PLANNING COMMISSION REPORT Regular Agenda -Public Hearing Item

PC Staff Report 6/23/14

ITEM NO. 1B PRELIMINARY DEVELOPMENT PLAN FOR HERE @ KANSAS; 1101 AND 1115 INDIANA ST (SLD)

PDP-14-00183: Consider a Preliminary Development Plan for HERE @ Kansas, located at 1101 & 1115 Indiana St. Submitted by Hartshorne Plunkard Architects on behalf of HERE Kansas LLC, Contract purchaser. Berkley Flats Apartments, LLC and Georgia Bell, property owners of record.

Figure 4: Building Height Summary - Proposed PDP

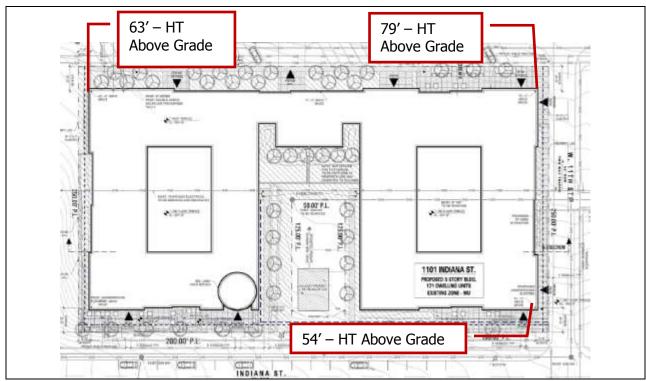
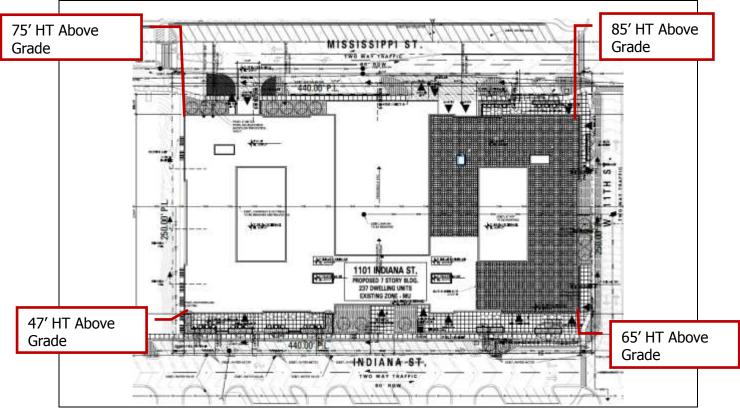
The proposed plan does not include this same data with regard to the maximum height shown on the site plan. Height of the development has been reviewed based on the building elevations included with the site plan (PDP-13 to PDP-16).

The proposed development requires revision to the overall building height or an adjustment to the development credits used to comply with the design standards.

The site plan must be revised to show the 14' setback on all sides of the development to use the PD building setback included in the Bonus Summary. Setback on the south side is required to minimize the impact of the development on the adjacent existing use.

Figure 5: Realigned Fambrough Dr and 11th St

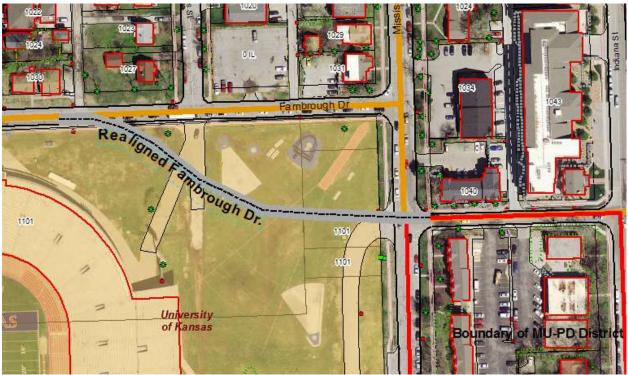
Staff is working with both KU and the developer regarding the possibility of realigning Fambrough Drive to intersect with W $11^{\rm th}$ Street. This street realignment may be coordinated to concur with the construction of the proposed redevelopment of 1101 and 1115 Indiana Street.

Figure 6: Angled Parking Exhibit with Parallel Spaces on S. side of Mississippi St.

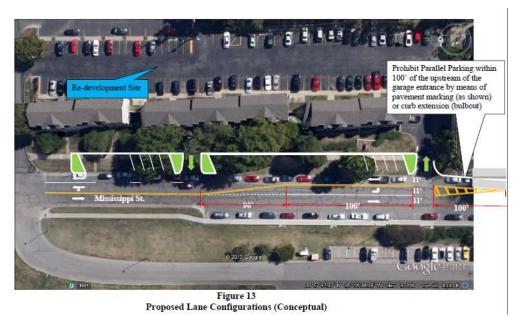
A significant concern expressed by many review agencies is the potential conflict with angled parking and bike/pedestrian activity. This area is one of the highest percent shares of bicycle/pedestrian travel counted in this area. Establishment of safe design is a critical consideration. In order to accommodate all uses within the Mississippi Street corridor, additional right-of-way width may be required.

An additional concern has been the establishment of an adequate bus stop along Indiana Street that meets the demands of City and KU transit systems. The number and frequency of busses, as well as a design that accommodates the street grade, turning radius and other design considerations are factors to be addressed. The final bus stop design may impact the number of on-street parking spaces.

Some width may be acquired from KU and would include relocating the sidewalk farther to the west. A minimum 6' wide sidewalk along the west side of Mississippi Street is required. A pedestrian easement could accommodate the 6' sidewalk without actually acquiring a right-of-way dedication. Space needed on the east side of Mississippi Street may need to include additional building setback from Mississippi Street, dedication of additional right-of-way and/or dedication of additional easement. An adequate fire lane must be maintained along Mississippi Street as well. These elements will be clarified as the street design and on-street parking are further refined for this development project.

Figure 8: Indiana Street Parking

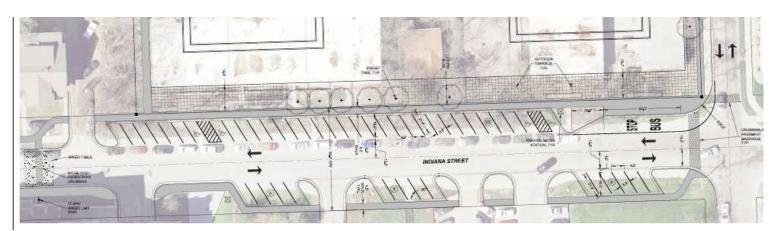
This plan proposes angled parking along the east side of Indiana Street. This segment of the street does not currently have any parking on the east side. The east side of Indiana Street is developed with multi-dwelling uses with driveways to private parking lots. Approval of the proposed design will impact the existing parking lots of some of these properties. Each of these property owners have been specifically notified of the proposed development and possible impacts to their property. As of the printing of this report, staff has not received any communication from these property owners.
